Title of Change:	Erratum to FPCN25897X to Include Internal Leadframe Design Change for FOD2712A, FOD2712AR2, FOD2712AR2V, and FOD2712AV
Effective date:	11 Aug 2026
Contact information:	Contact your local onsemi Sales Office
Type of notification:	This Product Bulletin is for notification purposes only. onsemi will proceed with implementation of this change upon publication of this Product Bulletin.
Change Category:	Wafer Fab Change, Assembly Change
Change Sub-Category(s):	Material Change

This notification serves as an erratum to FPCN25897X, originally issued on 24 October 2024, to include internal leadframe design change.

Item	Current	After Change
1	Internal DAP design: 	Internal DAP design:

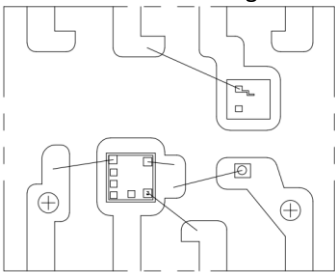
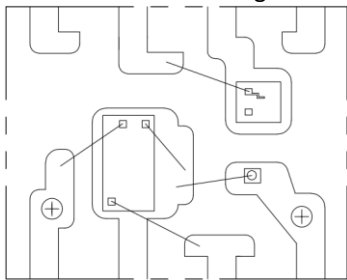
Specifically, the Die Attach Paddle (DAP) size has been increased to better accommodate the alternate die source identified under Change Item 2 of FPCN25897X. This additional change impacts only the following products:
